M5 Junction 10 Improvements Scheme

Change Application Consultation Statement

TR010063 - APP 10.38

Change Application Consultation Statement

Figure 3-3 Link Road cross-section with proposed changes

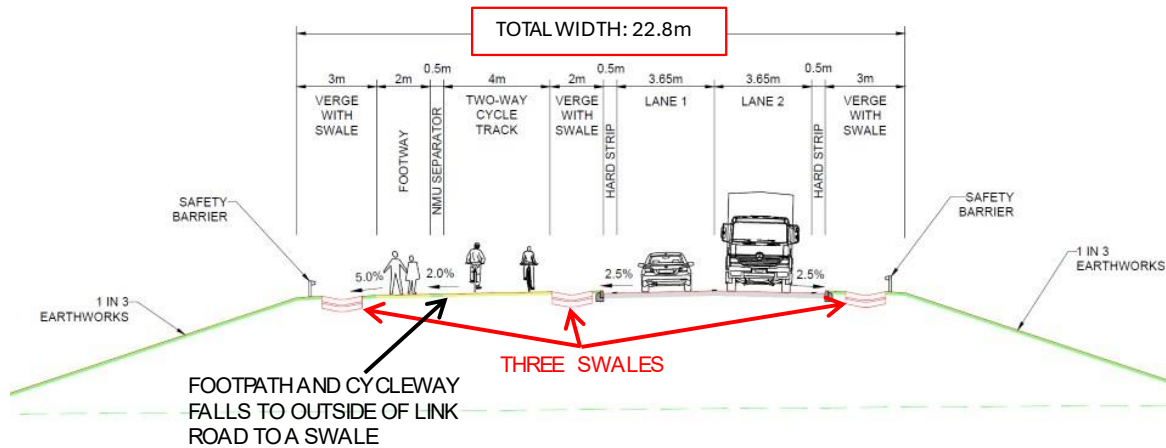
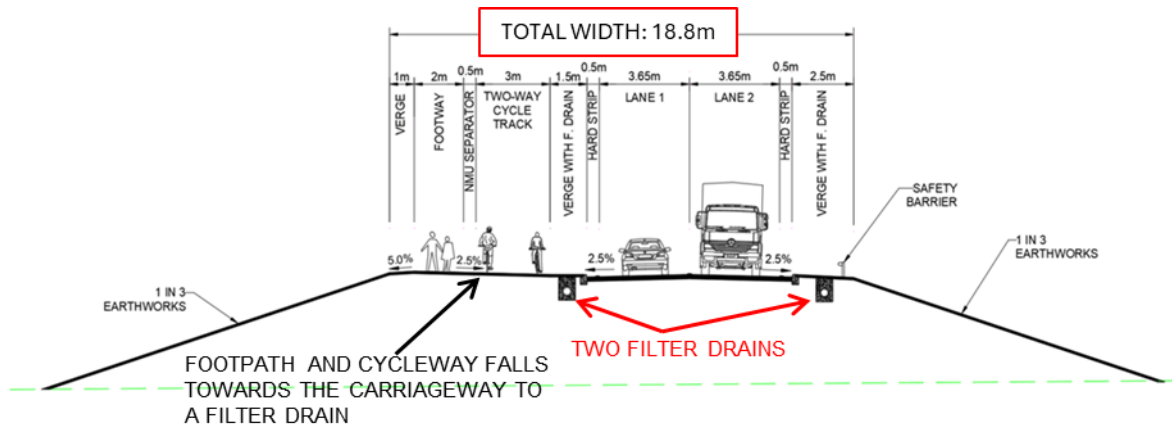
- 3.2.1. The Scheme currently proposes three runs of swales as the surface water collection method on the Link Road [see Figure 3-2].
- 3.2.2. The Applicant proposes to replace the swales with filter drains. Filter drains provide the following improvements:

- Can connect to bridge deck drainage solutions for the River Chelt bridge, and the flood alleviation bridges.
- 3.2.3. Furthermore, altering the cross-section of the Link Road means that the number of filter drain runs can be reduced from three to two [see Figure 3-3].

Figure 3-5 Elevation of the flood alleviation bridge

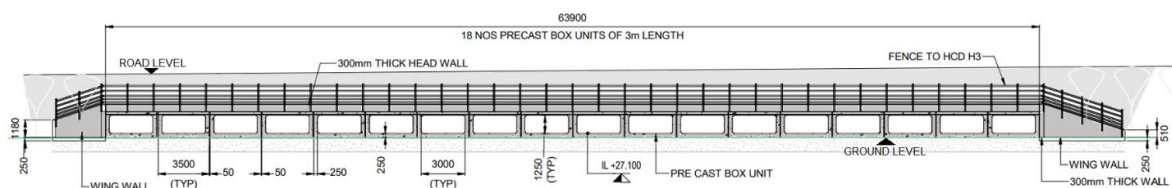
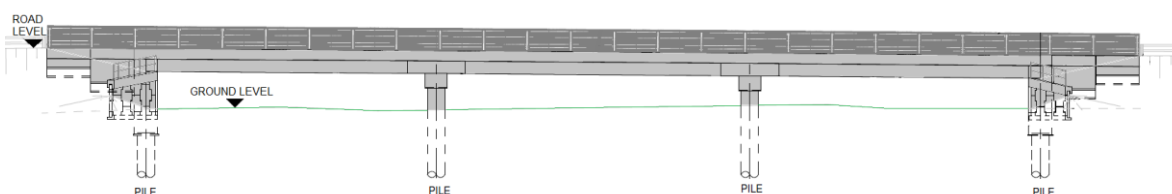
- 3.3.1. The Scheme design proposes two flood alleviation structures on the Link Road, to allow flood water to pass under the Link Road [see Figure 3-4]. These structures were to be constructed from rectangular, precast concrete units, to create a series of culverts.
- 3.3.2. Through a buildability review, several key risks were identified for the proposed culverts:
- As the culverts would be constructed from individual units, there is a risk that the units could settle by variable amounts. This would affect the rideability of the road and could damage the road surface.

3.3.3. The Applicant proposes to change the flood alleviation structures from culverts to bridges [see Figure 3-5]. These bridges would provide the following betterment:

Figure 3-8 Plan of proposed square River Chelt bridge with straighter River Chelt

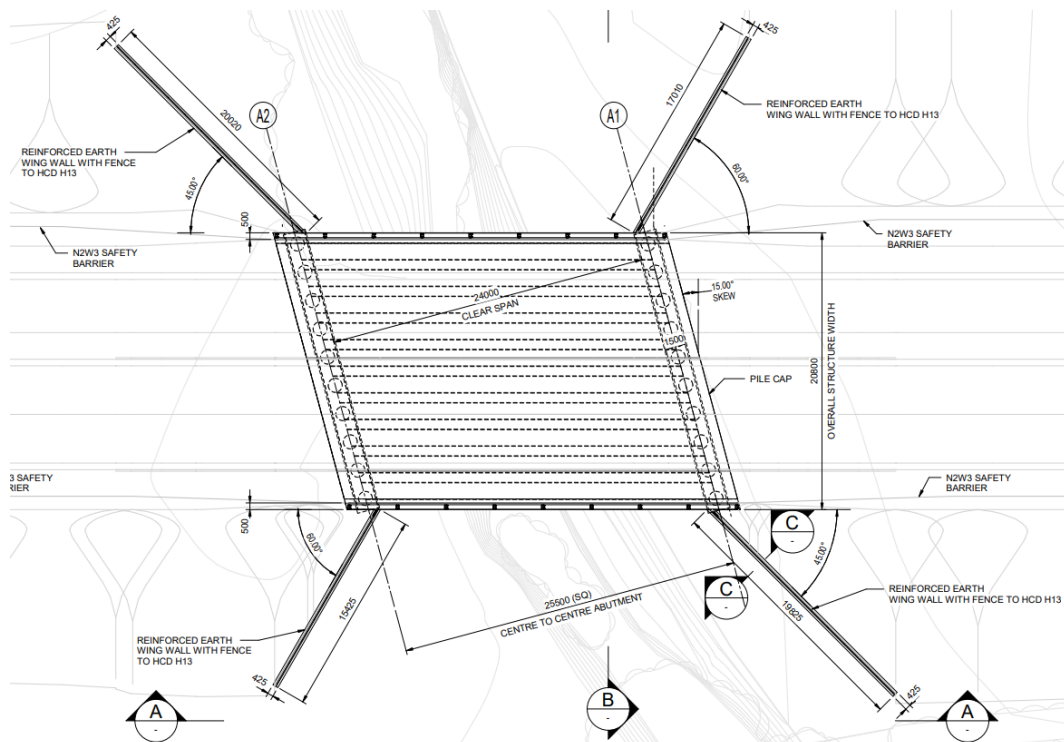
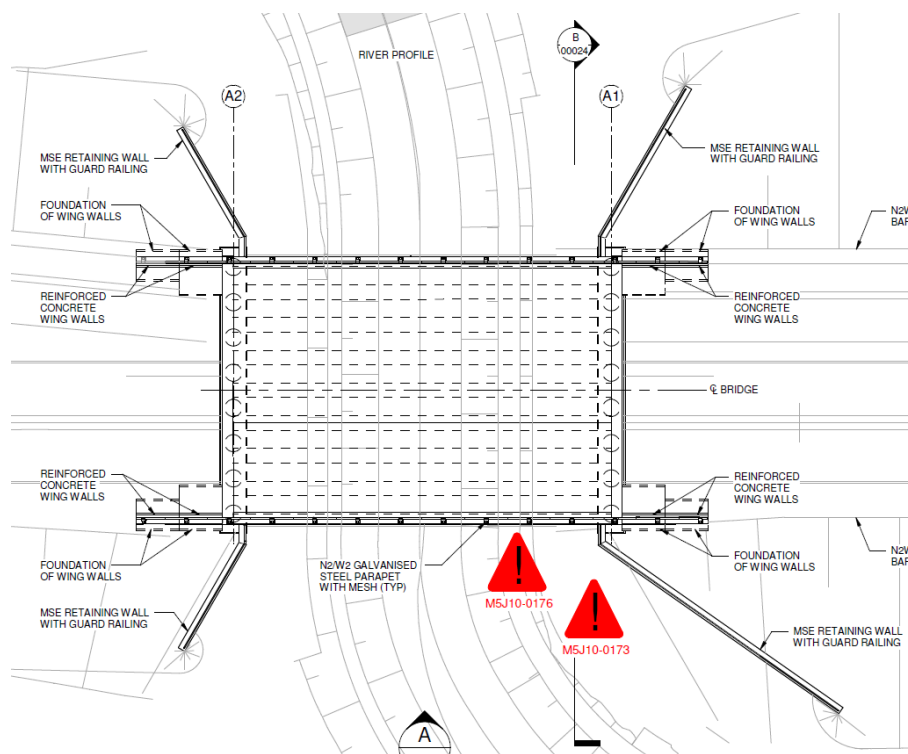
- 3.4.1. The bridge over the River Chelt proposed in the current Scheme is a skewed structure [see Figure 3-7], i.e. the bridge abutments are not perpendicular to the Link Road. The Scheme design also includes some reprofiling of the existing riverbank to reduce the risk of erosion and create more natural channel profiles [see Figure 3-6].
- 3.4.2. Skewed bridges are more difficult to design and construct and they introduce risk to the construction programme. Also, bridges with abutments that are perpendicular to the road generally perform better in the long-term, reducing the maintenance requirements.

- 3.4.3. The Applicant proposes to optimise the riverbank reprofiling works to straighten the River Chelt over a short length, so that it runs perpendicular to the Link Road [see Figure 3-8]. This would remove the skew in the bridge, mitigate risk to the construction programme, and improve long term structure performance.

Figure 3-10 Link Road long-section showing Scheme design vs proposed change

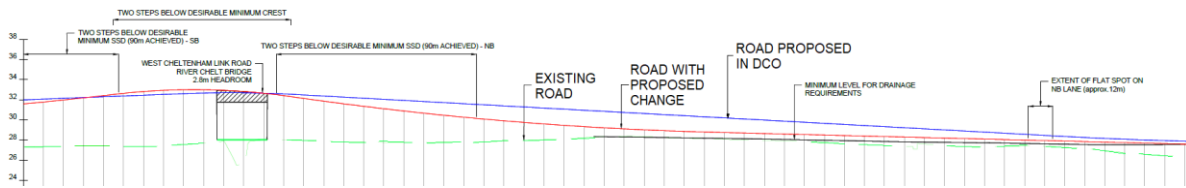
- 3.5.2. The Applicant proposes to optimise the vertical alignment of the Link Road beyond the LoD, by reducing the height of the road by over 1m in localised areas [see Figure 3-10]. This would result in significant reductions in the requirement for imported fill.

Figure 3-11 Existing TS location in Scheme design with dimensions for working room

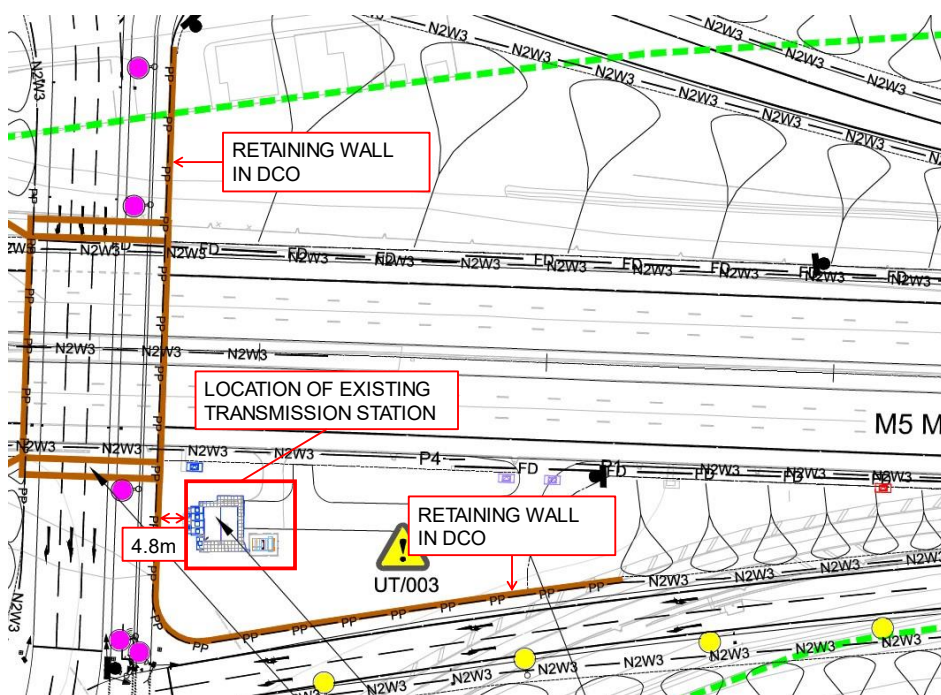
- 3.6.4. For these reasons, it has been determined that the TS needs to be relocated from its current location.
- 3.6.5. The new TS would be modular, similar to that shown in Figure 3-16, with approximate dimensions of 6.7m (L) x 4.8m (W) x 3m (H). The new TS will be located within the Scheme Order limits and highway boundary, approximately 2.6km south of the existing location [see Figures 3-14 and 3-15]. There is existing hardstanding in the verge of the southbound carriageway which would provide a suitable location.

Figure 3-18 Plan of alternative flood storage area

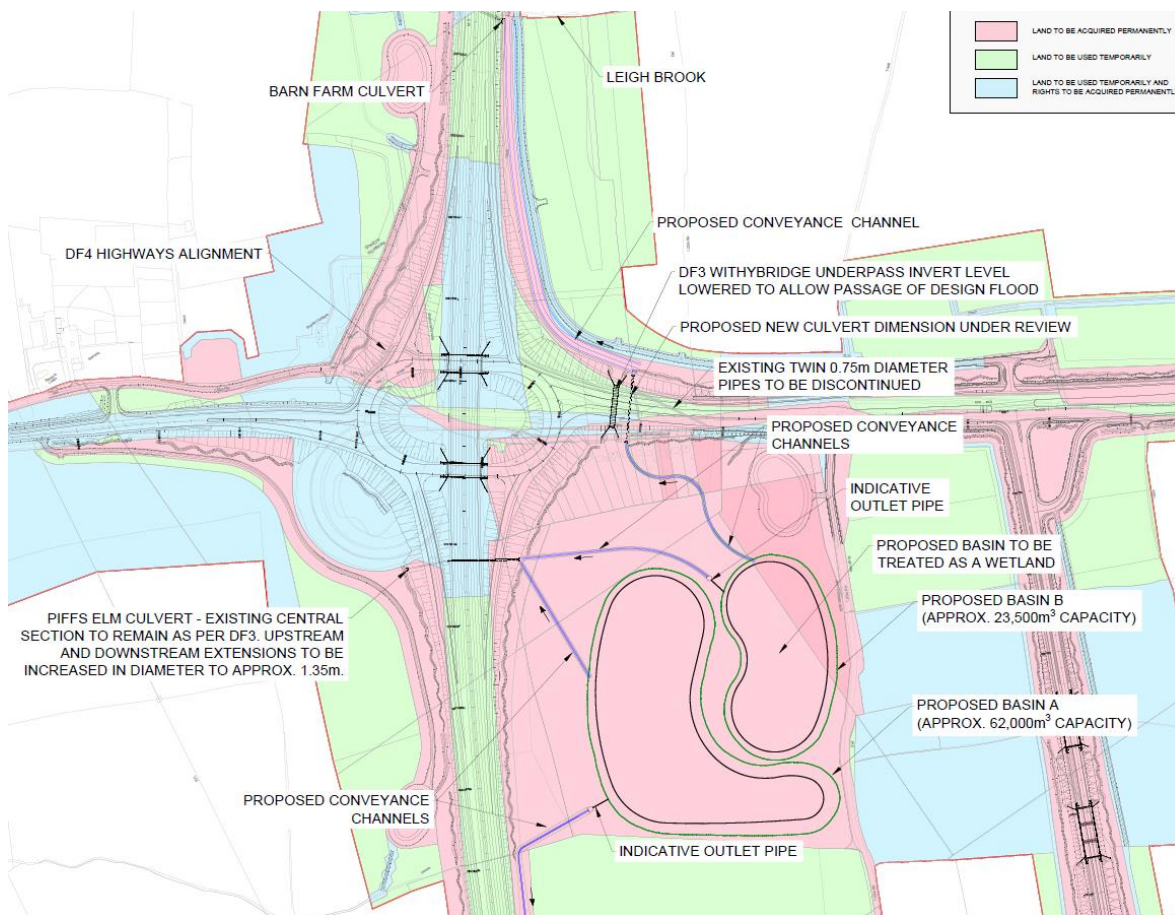
- 3.7.3. The Applicant proposes an alternative flood storage solution which would allow flood waters to flow north of the A4019 and reduce the volume of water that would be stored to the south-east of the Piffs Elm Interchange [see Figure 3-18].

Figure 3-19 Location of the infill of the northbound on-slip loop

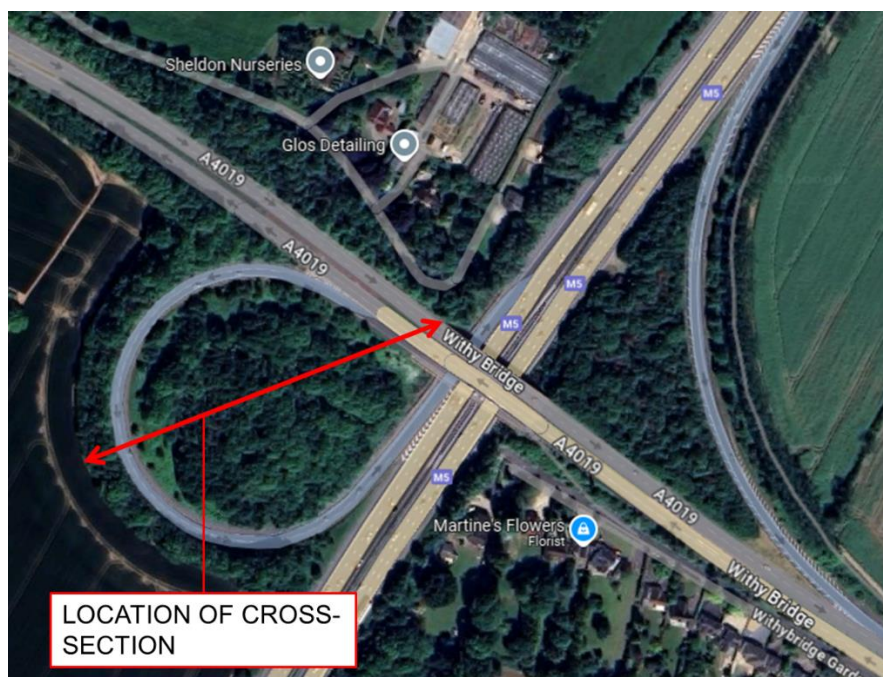
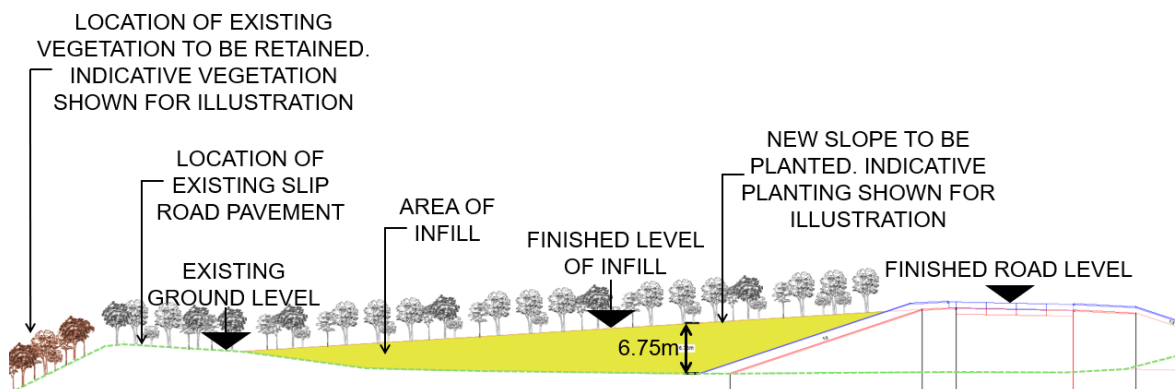
- 3.8.1. The existing M5 J10 northbound on-slip loops onto the M5 carriageway. The current Scheme design proposes to retain the embankment loop in its current form.
- 3.8.2. The Applicant proposes to infill the loop with site won material [see Figures 3-19 and 3-20], which is not suitable to be reused elsewhere, in order to create a new slope for planting and provide improved screening of the Piffs Elm Interchange.
- 3.8.3. This proposal would reduce the export of unsuitable material, thereby reducing the number of construction vehicle movements and the Scheme greenhouse gas emissions.
- 3.8.4. This change would ease the maintenance of the proposed planting as the gradient of the south-west embankment of the Piffs Elm Interchange would be significantly reduced.
- 3.8.5. The environmental effects of this change are outlined below:
